ECE/TRANS/WP.29/GRE/2007/12
28 December 2006

LIGHT-EMITTING DIODE (LED) MODULES FOR ROAD ILLUMINATION DEVICES

Regulation No. 112

Proposal for draft amendments to Regulation No. 112

"Annex 4 - Appendix 1

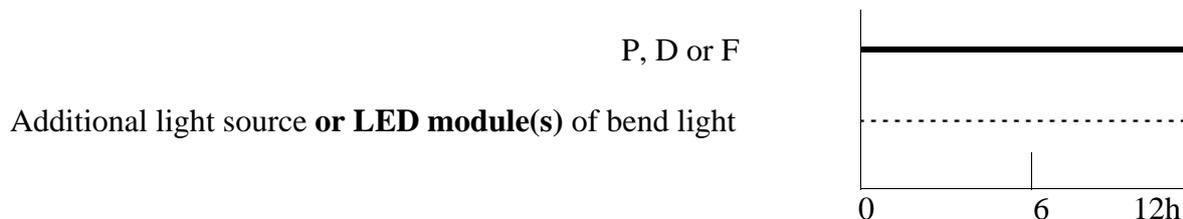
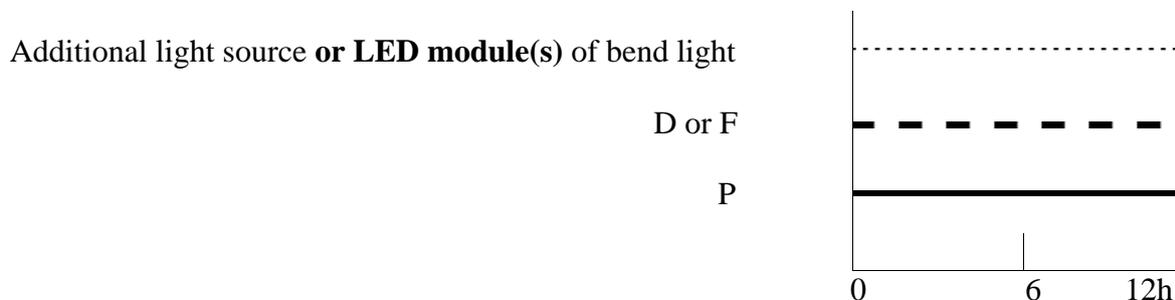
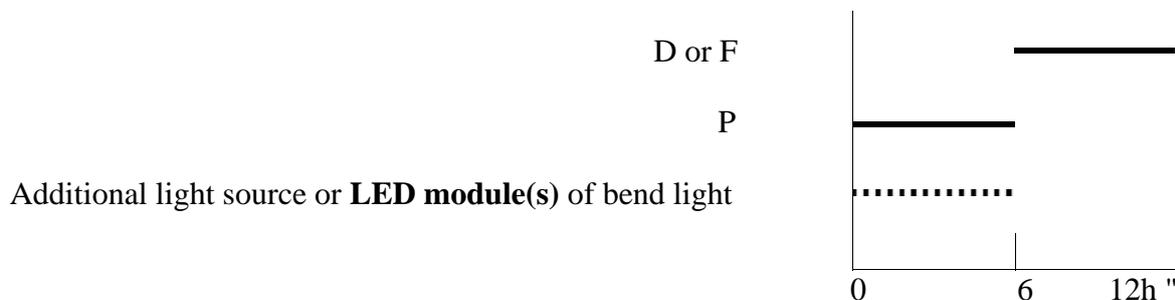
- (e) In the case of a passing beam designed to provide bend lighting with the addition of a **filament** light source **and/or one or more LED module(s)**, this light source **and/or LED module(s)** shall be switched on for one minute, and switched off for nine minutes during the activation of the passing beam only (see Annex 4 – Appendix 1)."

Annex 4 - Appendix 1, amend to read:

**A GENERAL ILLUSTRATION FOR PRINCIPAL PASSING BEAM AND BEAM
CONTRIBUTORS AND CORRELATED LIGHT SOURCE OPTIONS**

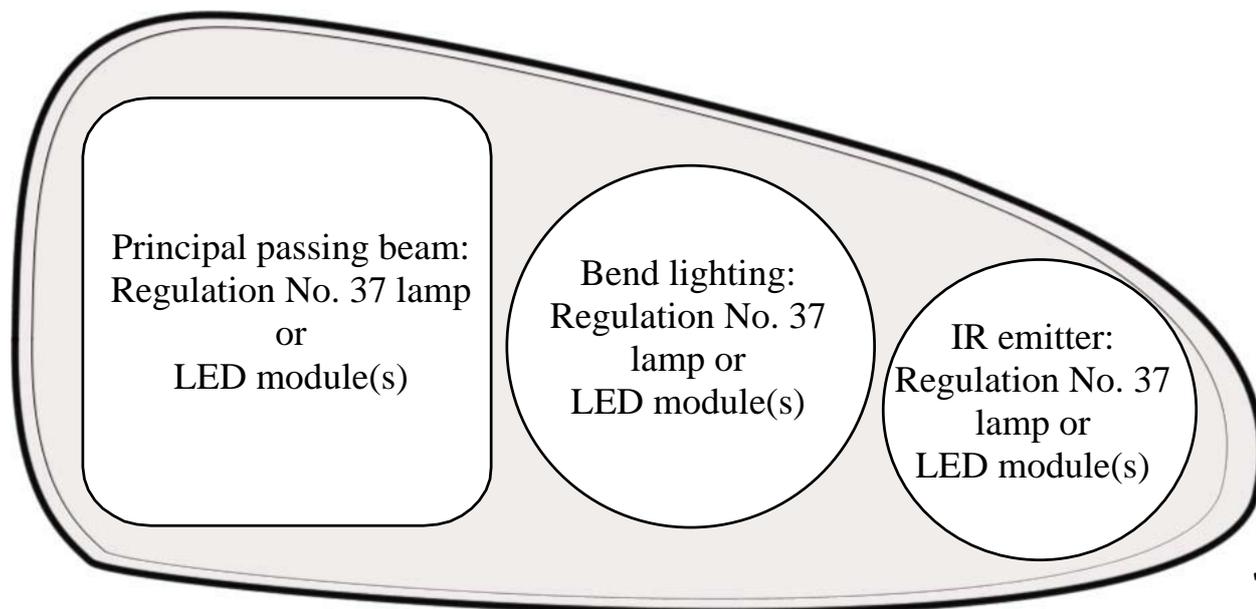
"6.2.10. Only one **filament** light source **or one or more LED module(s)** are permitted for **the principal** passing beam. Additional light sources **or LED modules** are permitted **only** as follows (see **Annex 10**):

In the meantime, GTB has further reviewed the proposal and introduced additional amendments intended to clarify light source options as already defined in paragraph 6.2.10. For that purpose, the illustrating sketch was moved from the justification part to the new Annex 10. The new term "principal" passing beam was introduced into the text in order to remove inconsistencies.
